PRODUCT/PROCESS CHANGE NOTICE (PCN)

PCN #: TB-0510-02	DATE: 29-Nov-2005	MEANS OF DISTINGUISHING CHANGED DEVICES:
Product Affected: 48L Cerpack & 84L Flatpack (Refer to Attachment II for affected parts)		<input type="checkbox"/> Product Mark <input type="checkbox"/> Back Mark <input type="checkbox"/> Date Code <input checked="" type="checkbox"/> Other
Date Effective: 29-Dec-2005		Change in carrier color

ATTACHMENT I - PCN #: TB-0510-02

48L Cerpack Carrier

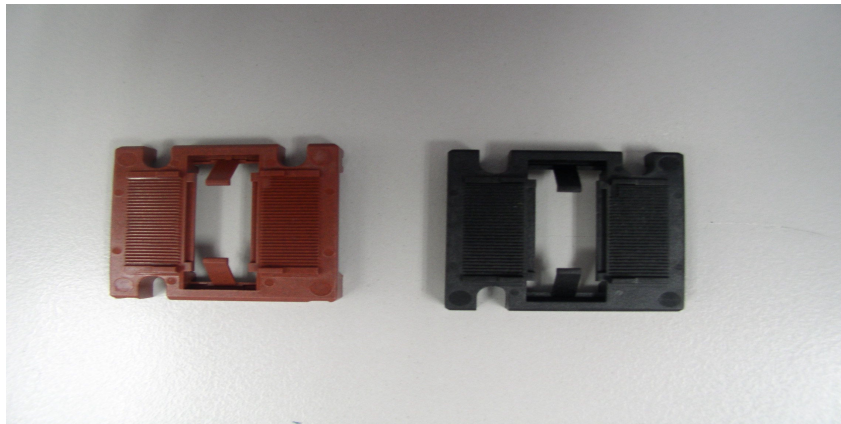
Detail of Change: There is no change in dimension for new carriers except for the color of carriers. For 48L Cerpack, carrier will be changed from red color to black color. For 84L Flatpack, carrier including carrier clip will be changed from green color to black color.
